**STAFF REPORT: AUGUST 13, 2025 REGULAR MEETING**

**APPLICATION NUMBER: HDC2025-00422**

**ADDRESS: 2200 CHICAGO BOULEVARD**

**SCOPE: ERECT FENCE, INSTALL VINYL WINDOW (WORK COMPLETED WITHOUT APPROVAL)**

*Designation photos taken 1974 (above)*

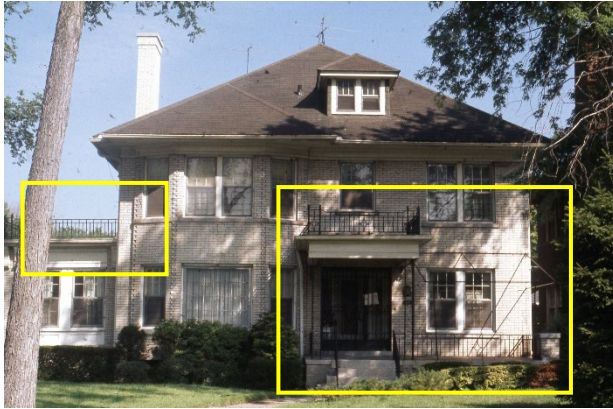
- Boston Edison Historic District was established in 1974.
- A COA (HDC2024-00376) has already been issued for the rehabilitation of the front porch. This includes the replacement of deteriorated porch deck tiles, replacing column bases and capitals, replacing box beams, soffit, frieze, corbels, beadboard ceiling panels, at the porch roof, rebuilding the trench gutter, repainting porch surfaces, and replacing conduit and ceiling box at front porch light fixture. During a recent site visit, staff observed work being done to the front exterior of the house, including the center window above the porch which has been changed without HDC approval.
- As seen in the 1974 designation photos, the house retains a wrought iron style front porch railing, and is a character defining feature of the house.
